Turbo HD DVR V3.3.1 Release Notes

Reference NO:	20151030_01
Product Classification:	Turbo HD DVR
Date of Publication:	October 20, 2015
Edit Department:	Overseas Technical Support Dep.

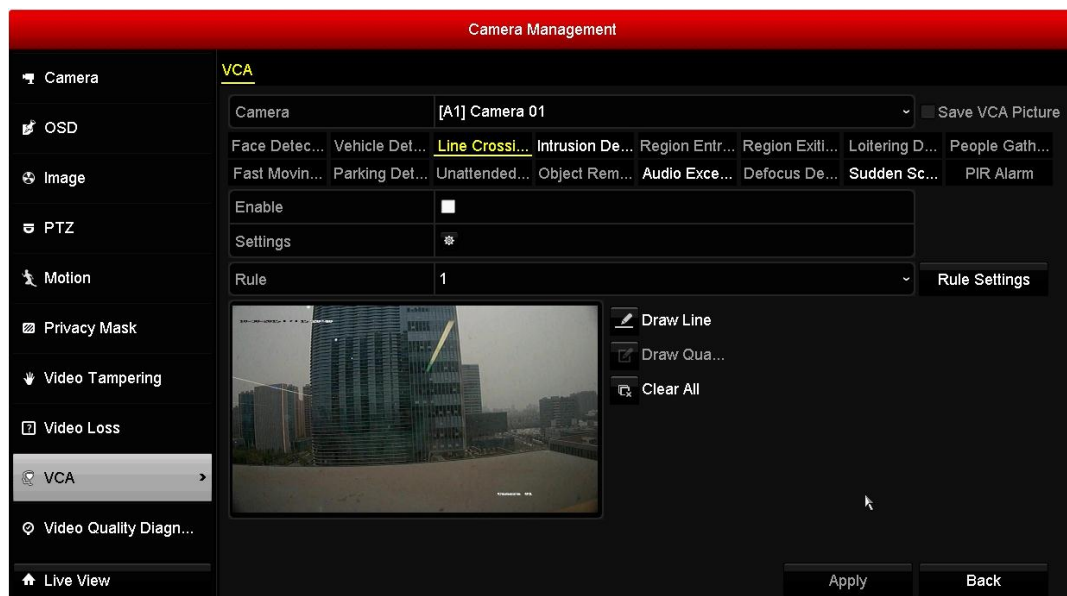
- iii. Add **VCA search** module on the DVR GUI menu in order to search out the required video clips for various VCA events, including **Behavior Analysis**, **Face Detection**, **Plate Search**, **People Counting** and **Heat Map** (VCA info is uploaded from IPCs and saved on the DVR HDDs);

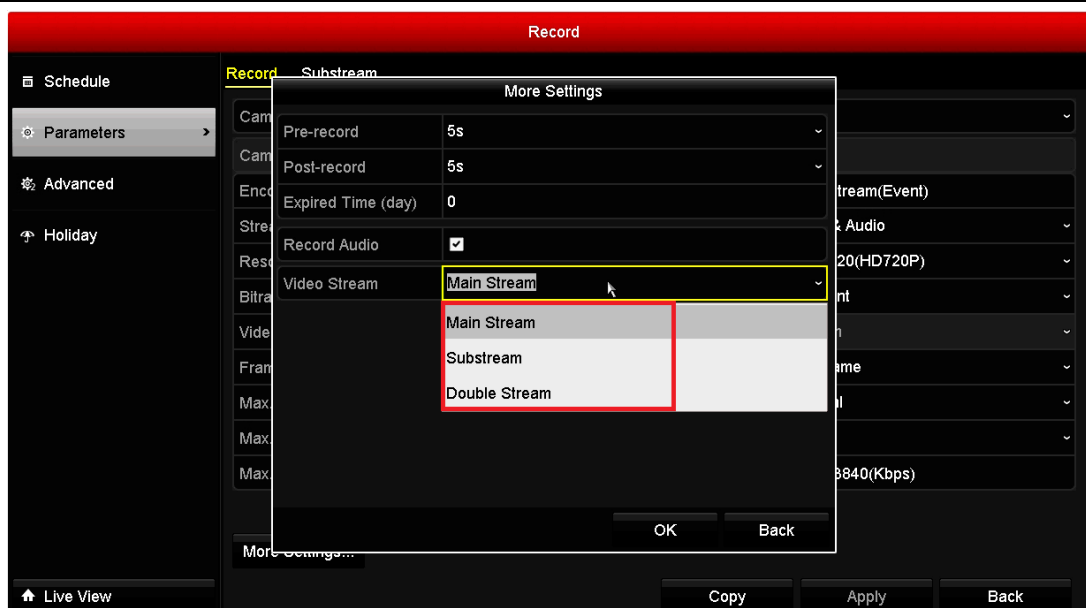
- iv. During Smart Playback for IPC channels, **Face Attributes**, including **Gender**, **Age** and **Wear Glasses or not** can be set as the filter condition;
- v. New VCA types as **Sudden Scene Change** is supported for analog channels on Part series of Turbo HD DVRs, and **Audio Exception Detection** is supported for all models;

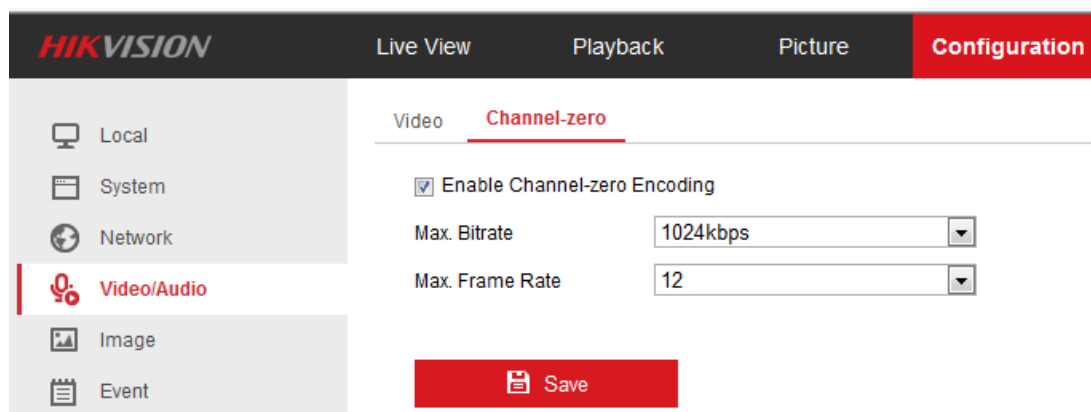
- vi. Newly add **Double Stream** recording type, thus it supports main stream and sub stream recording simultaneously: **Record**→**Parameters**→**More Settings**.

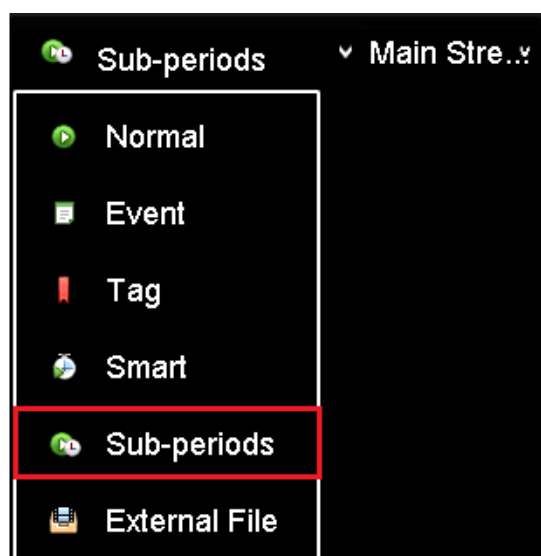
- vii. Newly add **Channel-zero** function on DS-7200HGHI-SH series Turbo DVR;

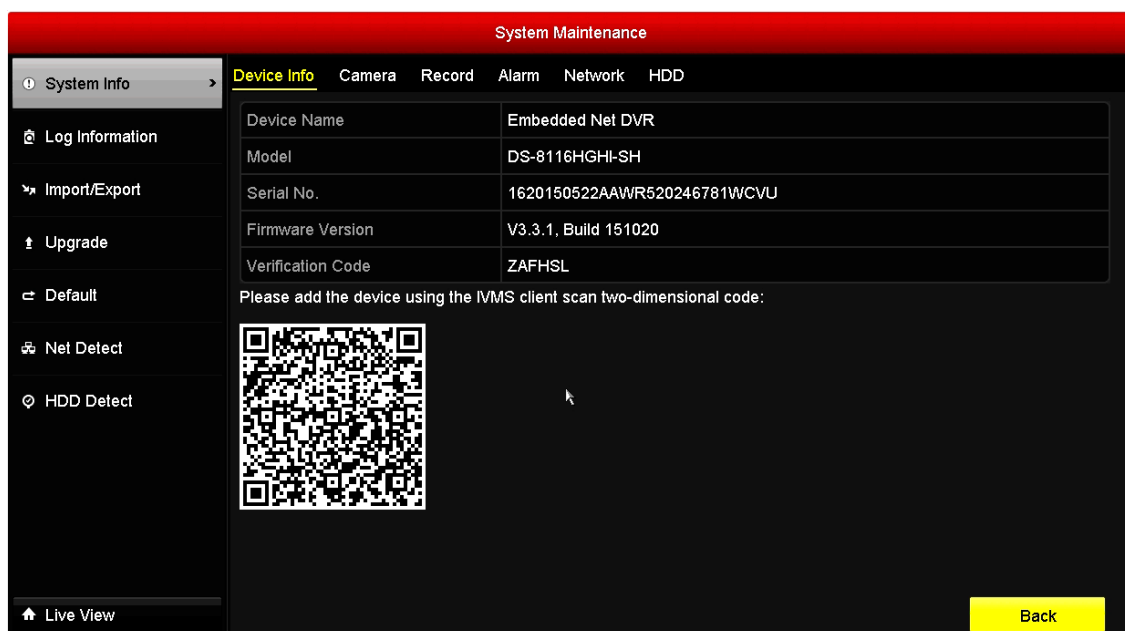
- viii. Support 1005K USB Keyboard access for control;
- ix. Support **Sub-periods** playback for selected single channel: **Menu->Playback->Sub-Periods**.

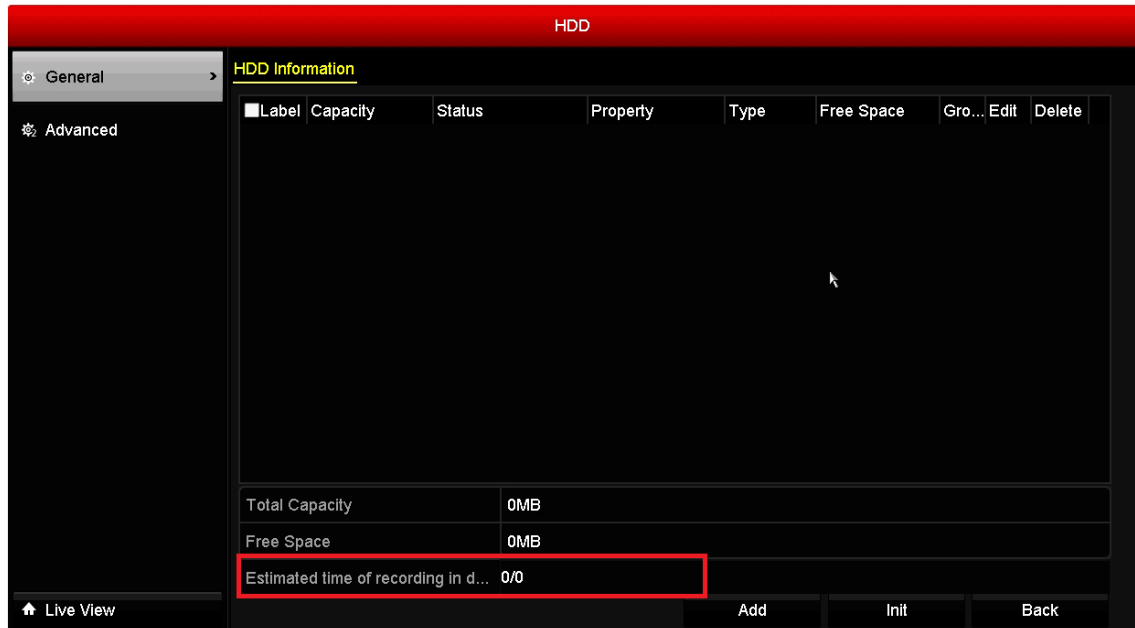
- xiv. Support Hikvision DVS, Fisheye cameras and EZVIZ cameras access;
- xv. Add the function of **copy and paste** for the edit box on local menu;
- xvi. Newly Add **DDNS status** display under the DDNS interface;

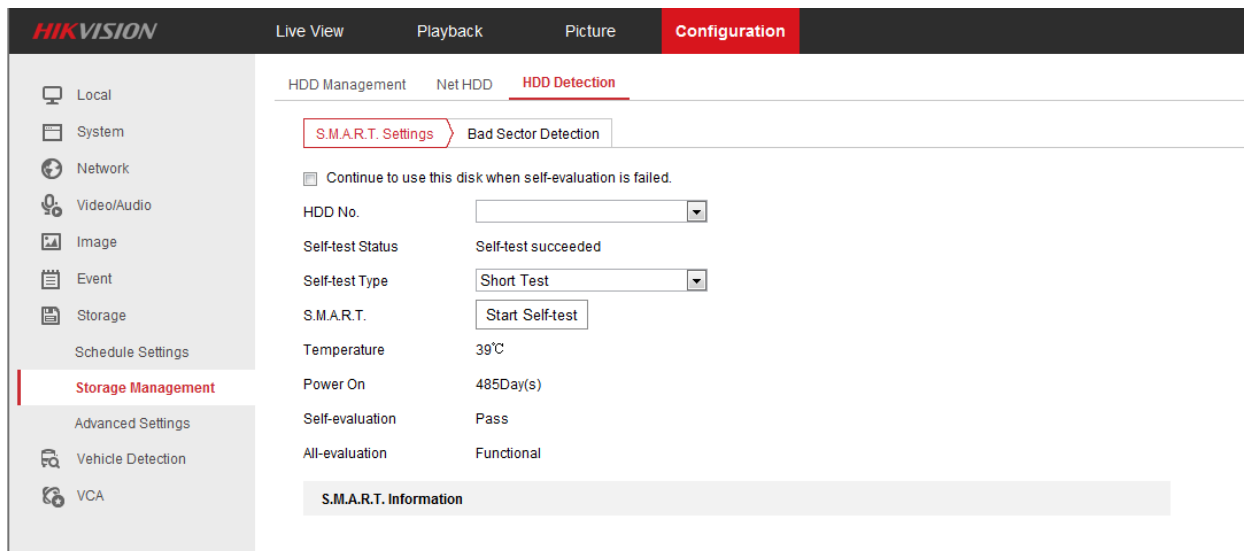
- xvii. Show the total recording time supported and estimated remaining recording time in HDD Management interface: **Menu->HDD->General**.

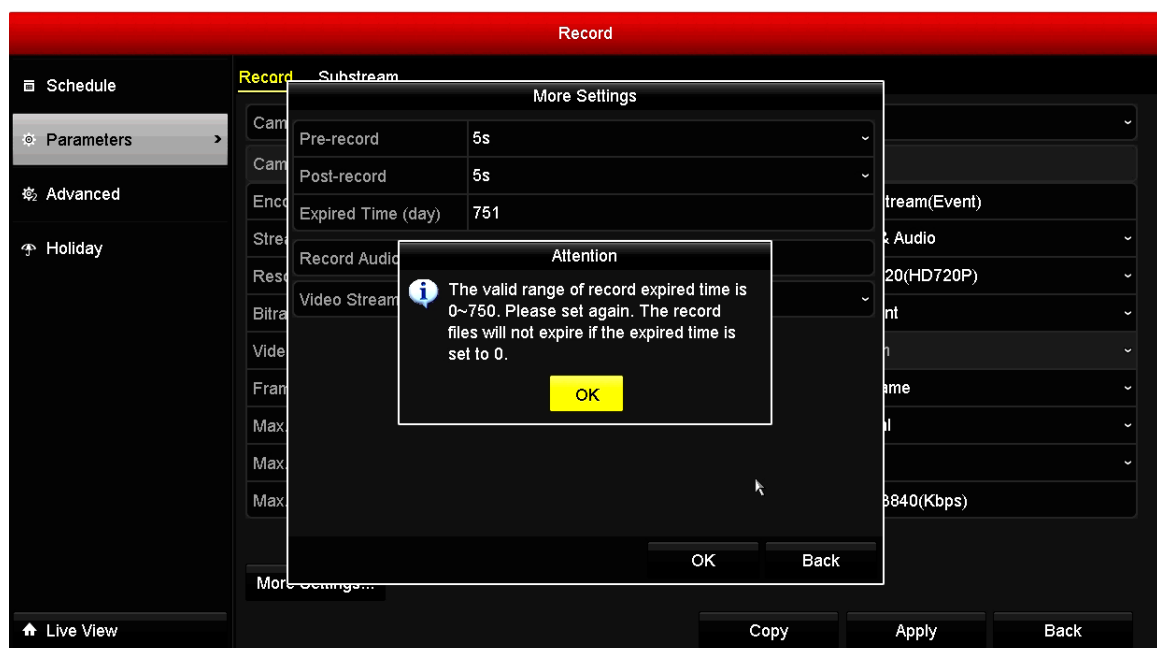
- i. Optimize the **Region/Country** under the DDNS interface, add some new countries;
- ii. Remove the **SNMP** function from the DVR under the network interface;
- iii. Max numbers supported for video search has been changed to 2000 from 4000;
- iv. Do not support eSATA disk format when the size is more than 2TB;
- v. Up to 8 IPSANs can be added as the network storage, while only 1 IPSAN is supported previously;
- vi. Optimize the streaming strategy for 4-division windows IP channels live view from sub streaming to main streaming as default in order to improve the live view quality.
- vii. Enhance the recording expired time up to 750 days from 60 days
